Project Name: New Haven BRF 0183(1)

Structure Identification: TH 2, Bridge 10

The precast concrete fabrication drawings associated with Items 540.10 Precast Concrete Structure (Abutment #1), (Abutment #2), (Approach Slab #1) and (Approach Slab #2) and Item 900.645 Special Provision (Precast Concrete/Steel Composite Pier Cap), has been reviewed and is being returned herewith.

Submittal Notes Rev #1 (To be used when reviewing shop drawing submittal)

1/F1 PRECAST CONCRETE & SURVEY LAYOUT

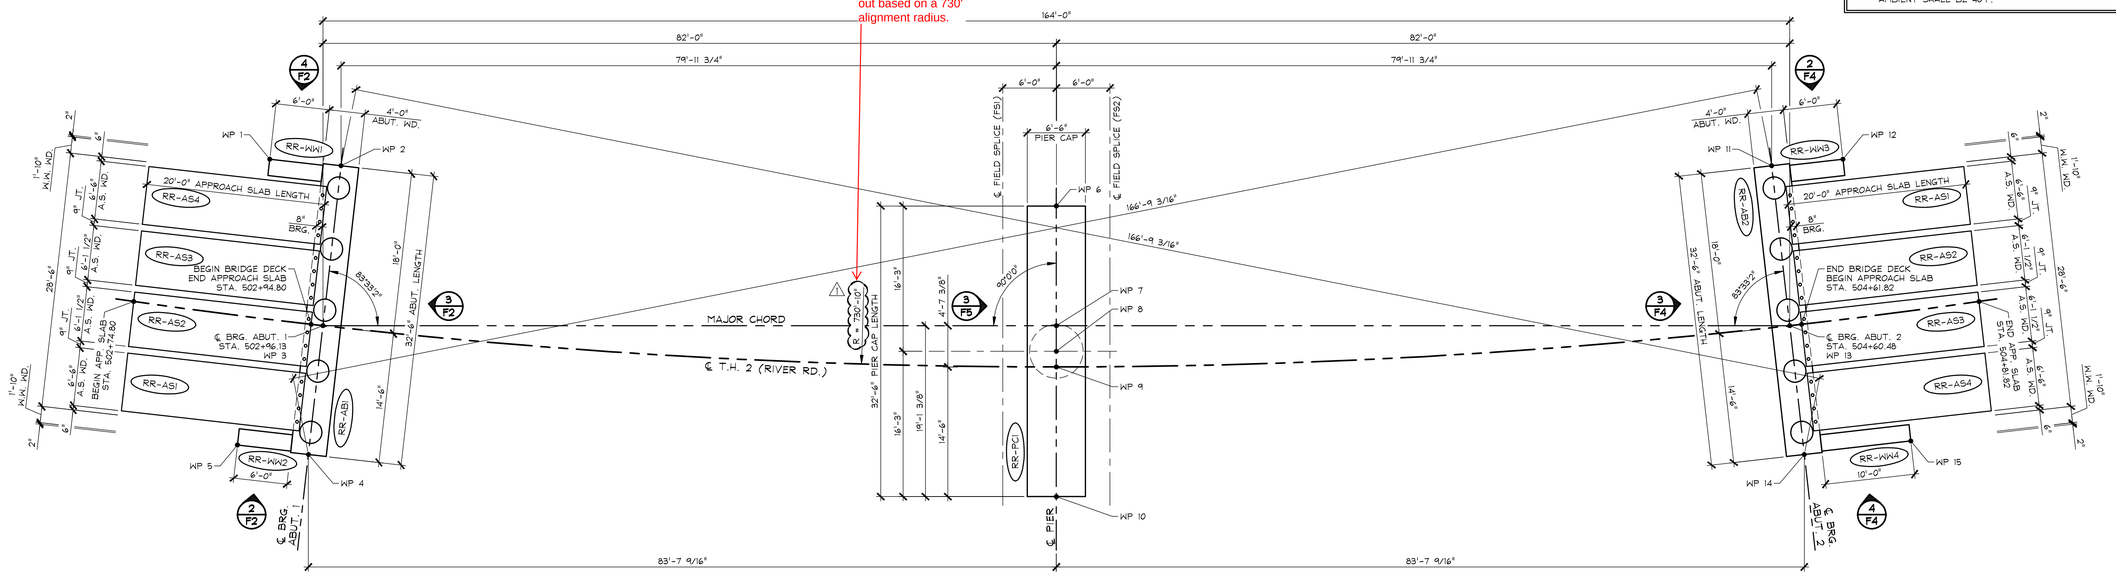
2 Must be 730'-0". All steel shops are laid out based on a 730' alignment radius.

A / F4 SHEAR KEY SECTION @ APPROACH SLABS

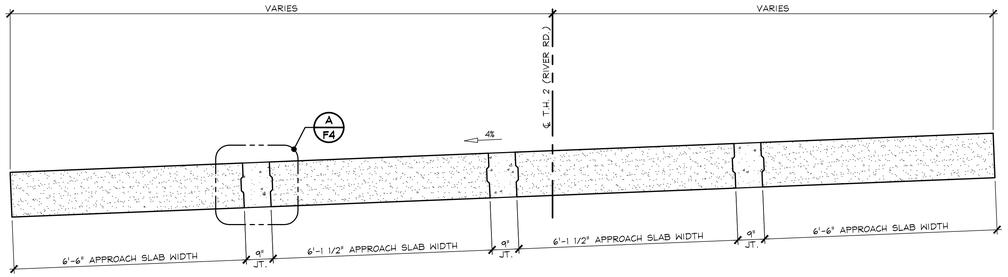
This joint detail does not match the standard details provided in the contract plans. However, similar details have been approved on recent VTrans Projects.

1 F5 PRECAST CONCRETE PIER CAP PLAN

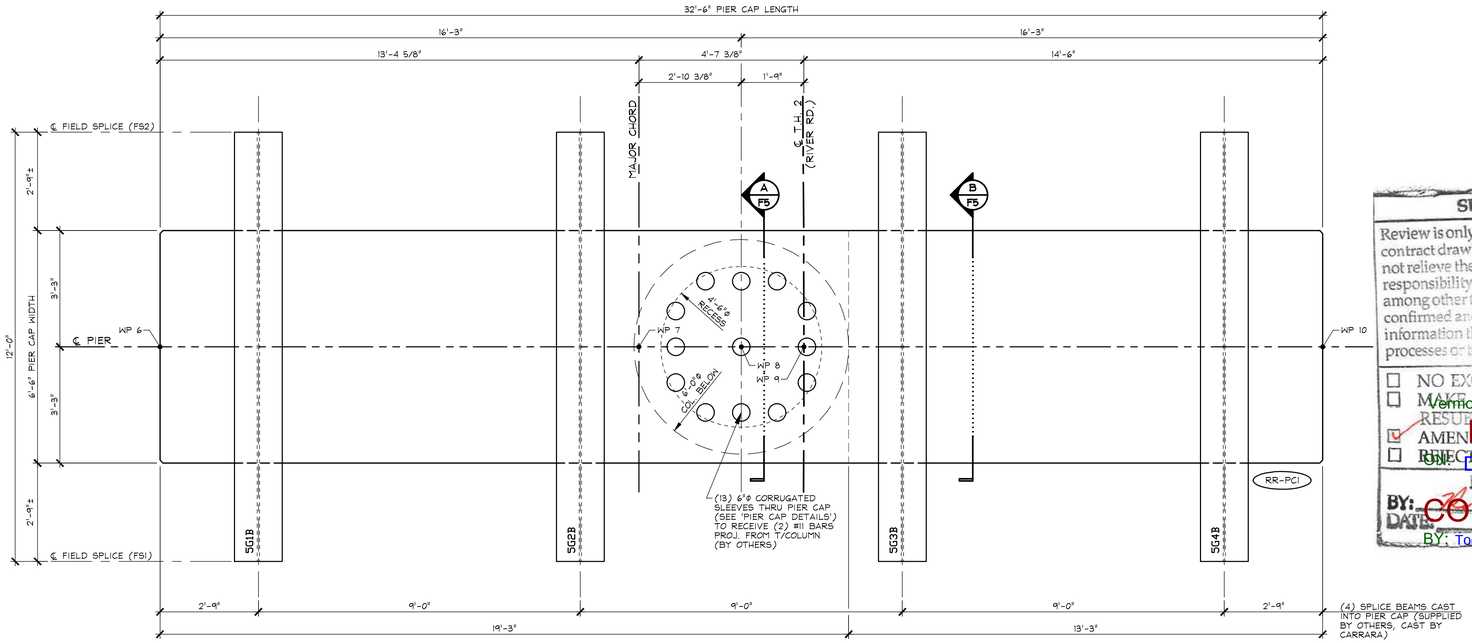
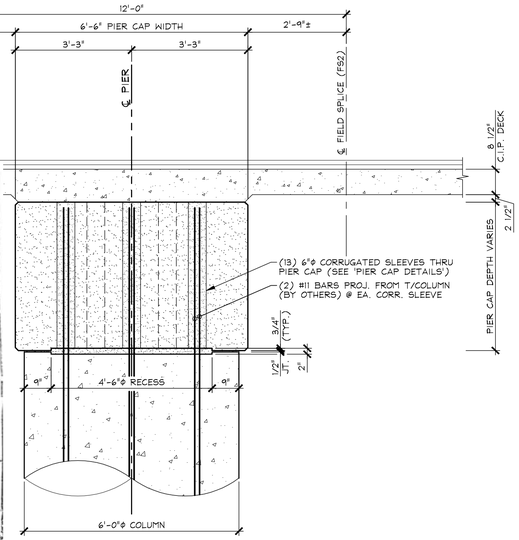
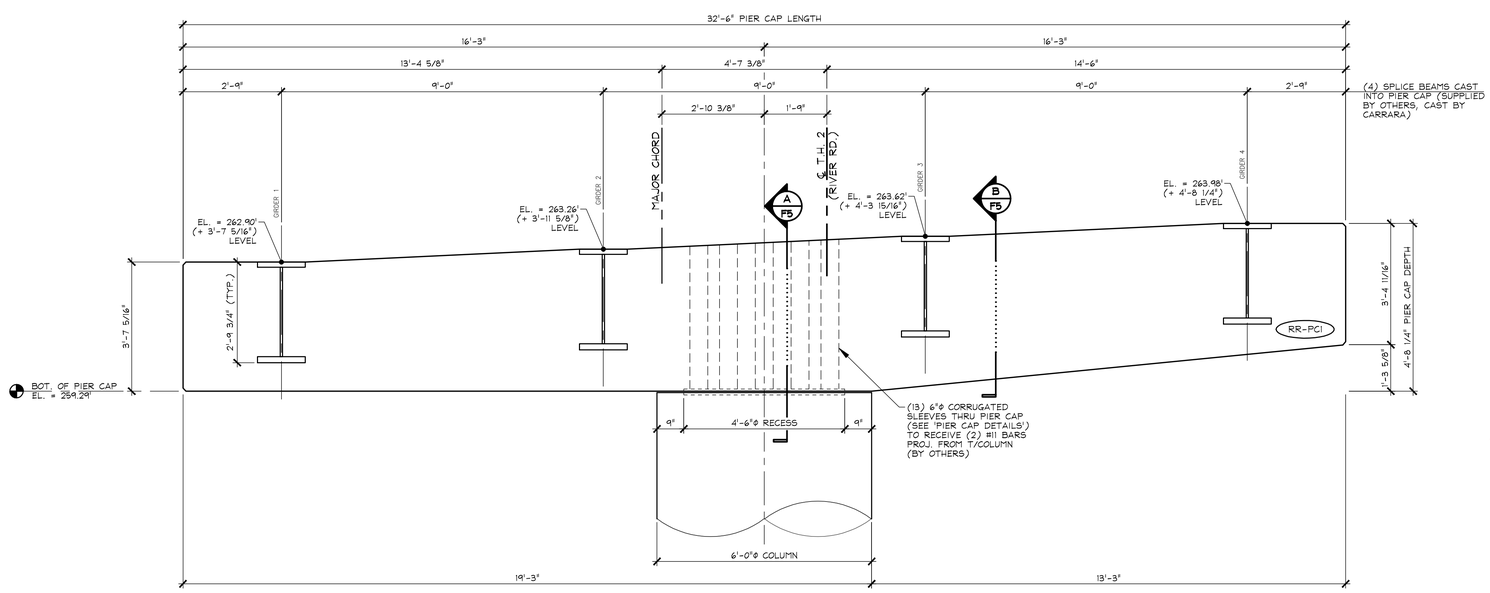
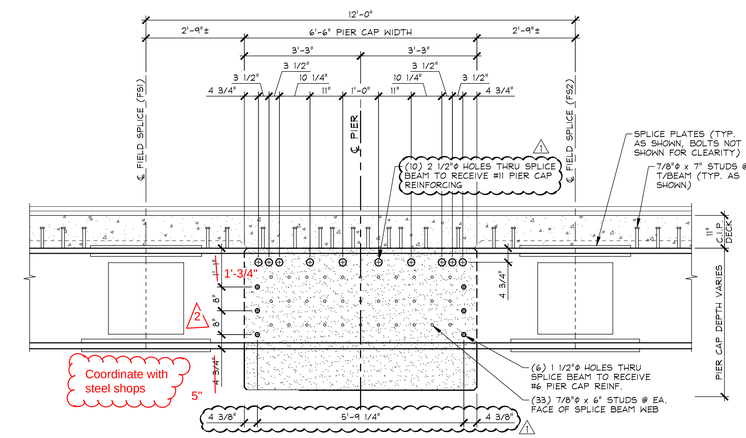
3. **Reference drawings F5 & PC1 and RFI 002**
   Please note approved change to location of #11 rebar and #6 rebar.
   The current steel shop drawings do not reflect this change.
   Hole size for #11 bar increased to 2.5" dia. – rev. #1
   Location for (6) vertical # 6 bars changes – rev. #1

Although the 2 and 13/16" cover on the bottom is okay above the pier stem, the design expectation would be to maintain the 3" cover on the underside of the pier cap once you are outside the area of the pier stem.

The changes to the horizontal positioning of #11 bars for the adjustment of side cover are acceptable. It should be noted that these changes need to be coordinated with the steel fabricator for placement of the holes in the webs, and that adjustments to the field placements of the shear studs and #11 bars in the deck will need to be made to account for the adjusted hoops.

The vertical location of the bottom bars shall be as indicated on the Contract Plans. A 2 13/16" clear cover (as noted in the RFI) is acceptable at this location.

1 ABI PRECAST ABUTMENT PLAN VIEW IN FORM
3/8" = 1'-0"

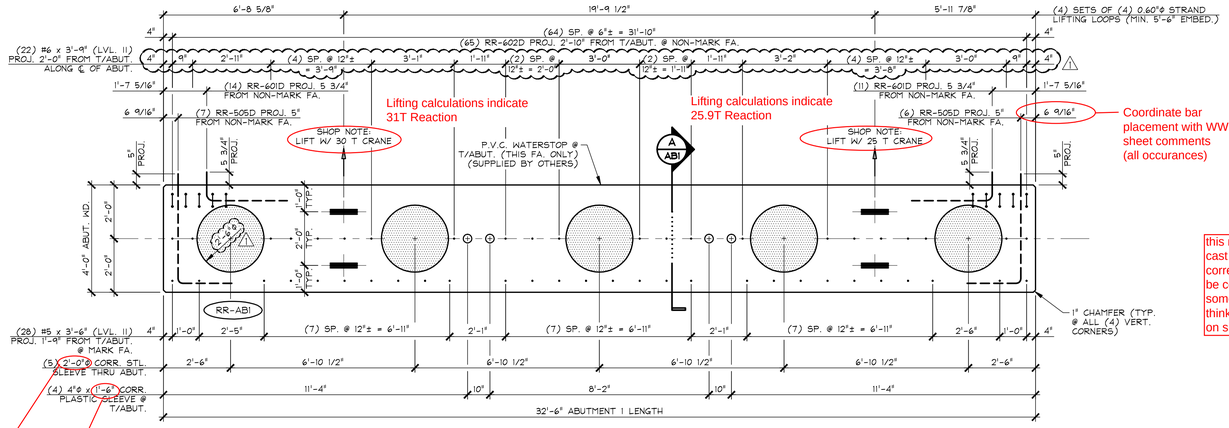
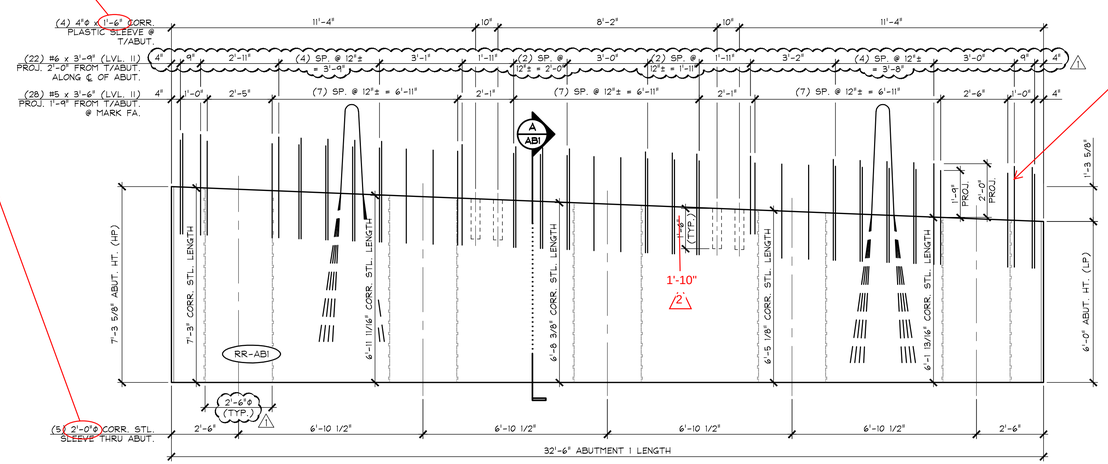
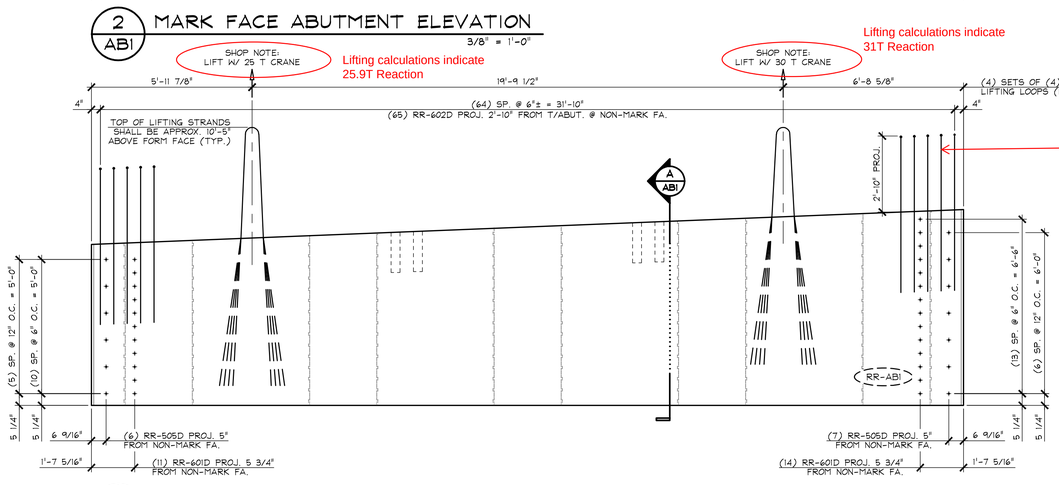
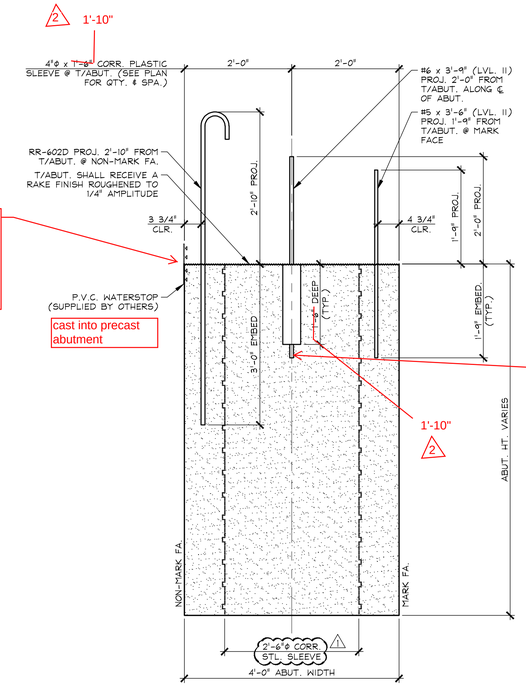
Lifting calculations indicate 31T Reaction

Lifting calculations indicate 25.9T Reaction

Coordinate bar placement with WW sheet comments (all occurances)

Why are only the first 5 indicated? Generally show all or just first and last?

this needs to be cast into precast correct? note might be confusing as in someone might think it will be done on site.

cast into precast abutment

1 AB2 PRECAST ABUTMENT PLAN VIEW IN FORM

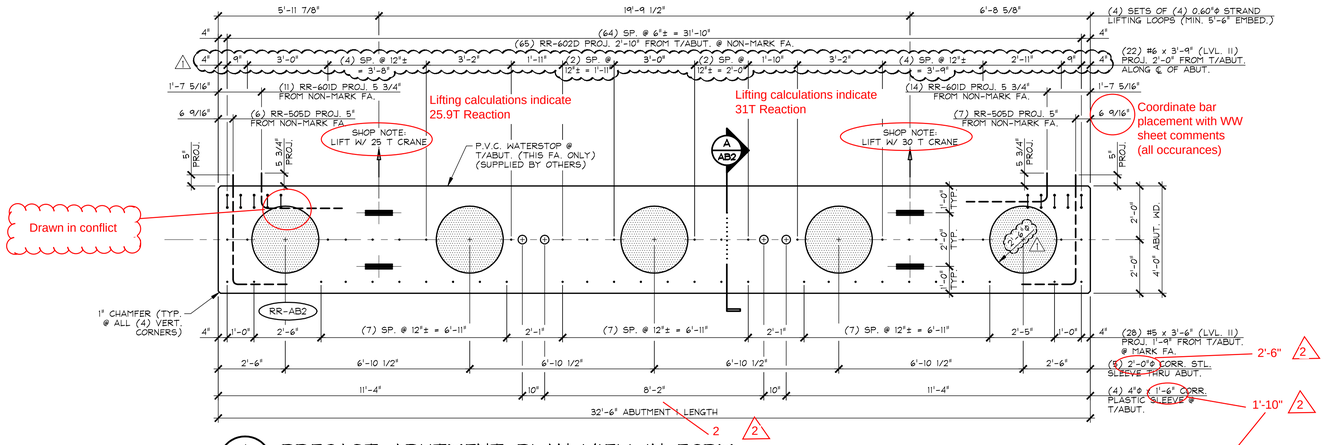
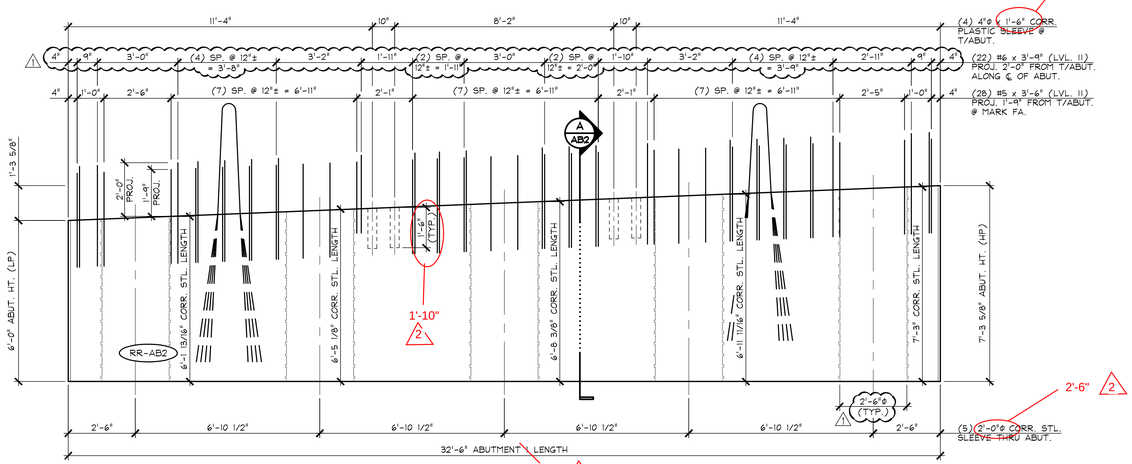
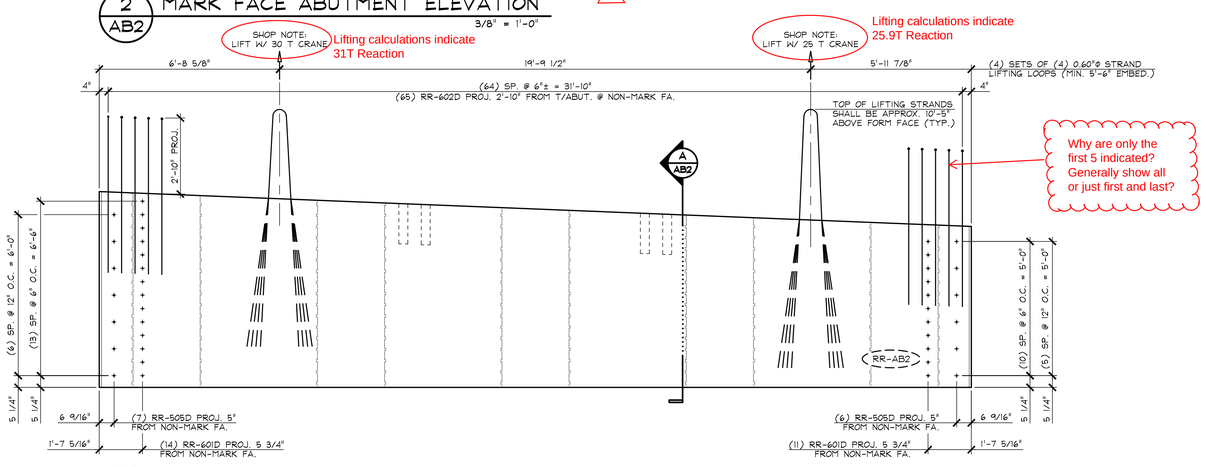
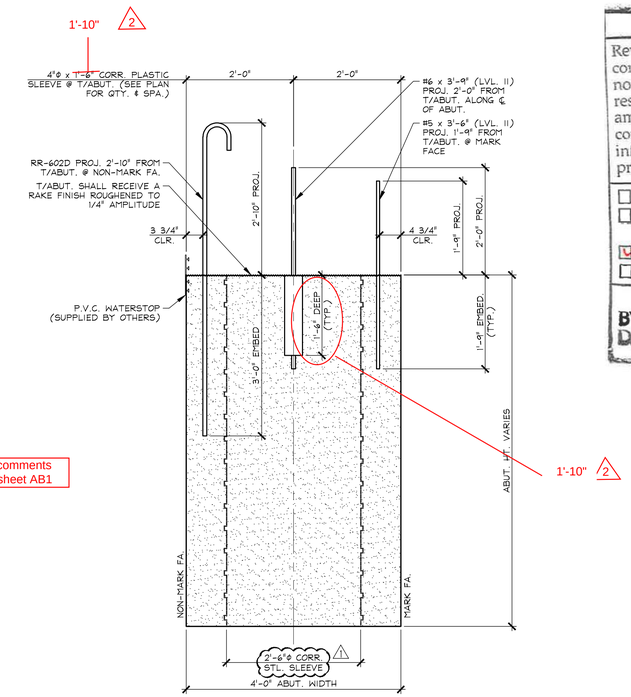
same comments as for sheet AB1

1 AB2.1 REINFORCING PLAN VIEW IN FORM

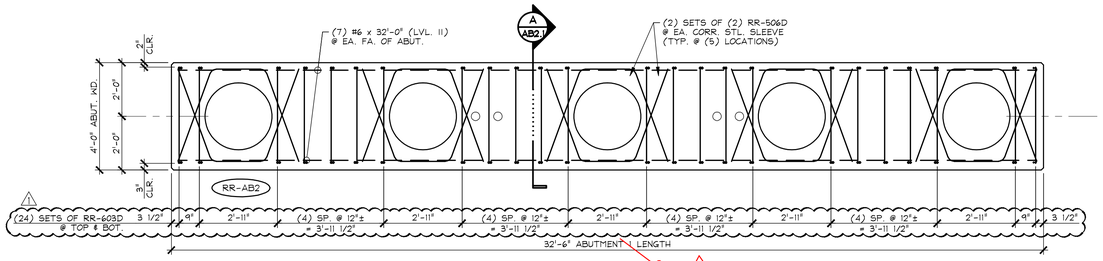
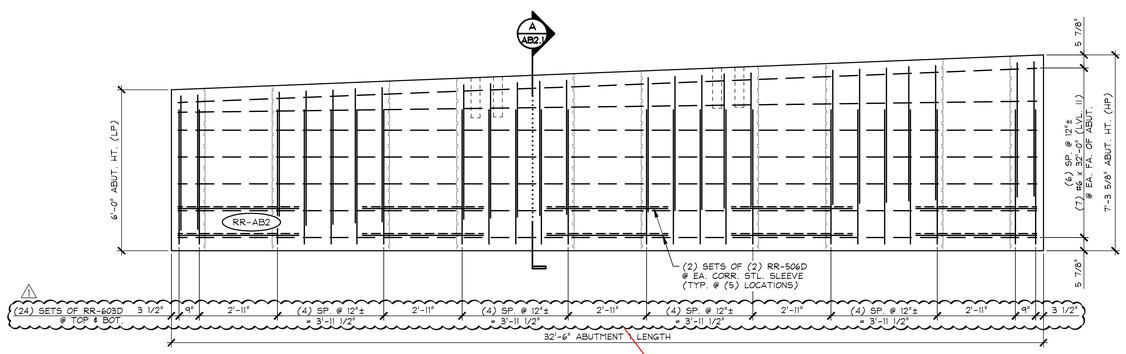
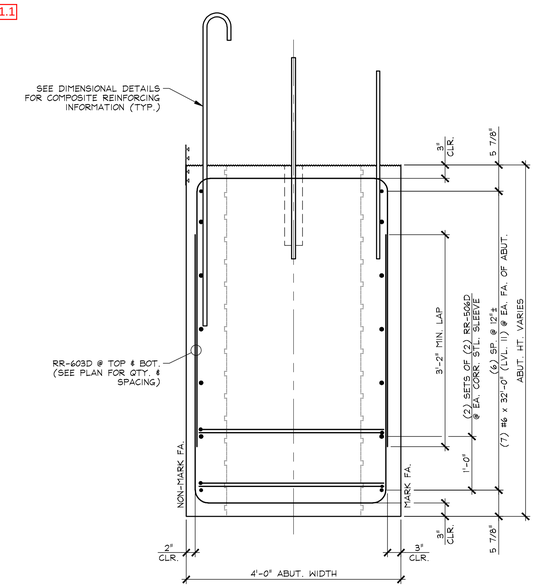
same comments as for AB1.1

1 / AS1 DIMENSIONAL PLAN VIEW IN FORM - "RR-AS2"
1/2" = 1'-0"

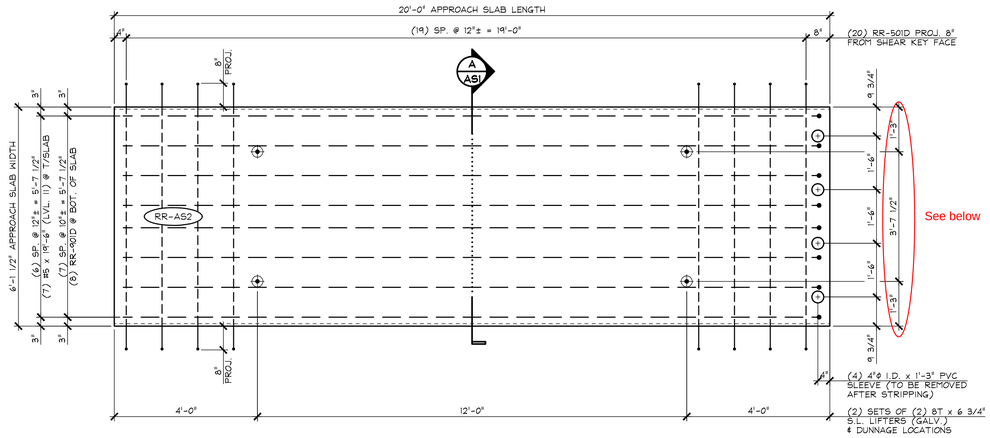
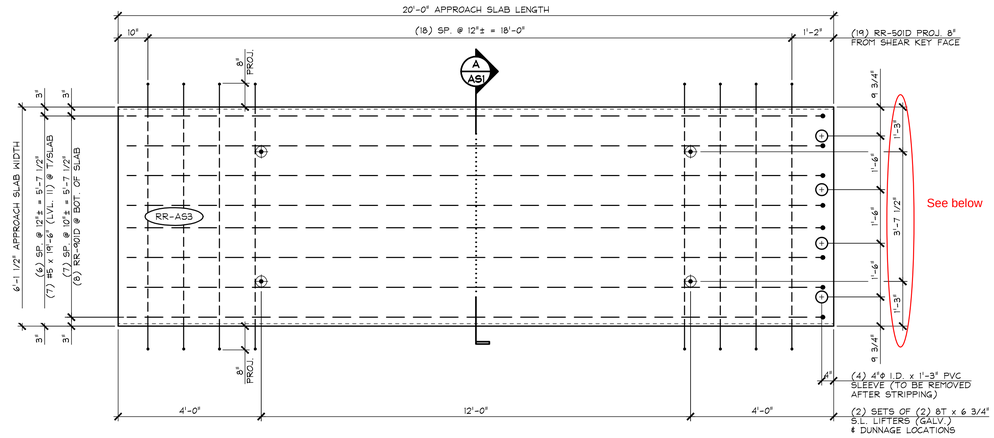
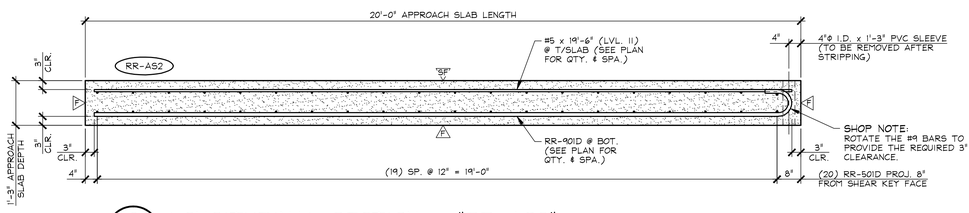
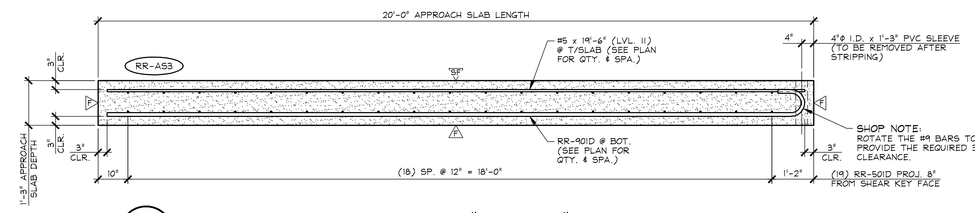
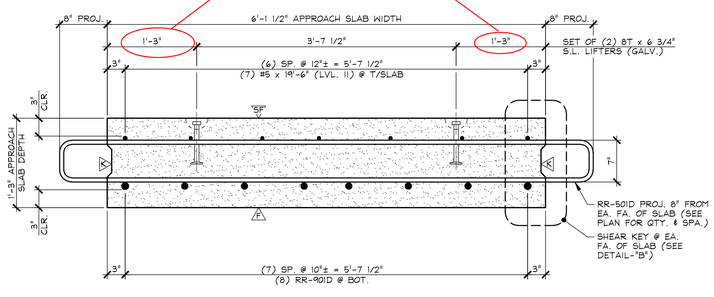
The minimum edge distance in the references provided in the lifting calcs is 21". This decreases to 16" for the 6400 lb lifter option. Recommend 1'-4" min. (all occurances)

See Note on Sheet F4 regarding this detail.

can't they name the sheet AS2 AS3 or something more relevant since that what the sheet is for. looking at sheets F1 - F3, AS1 is an outside approach slab. seems to make it more confusing
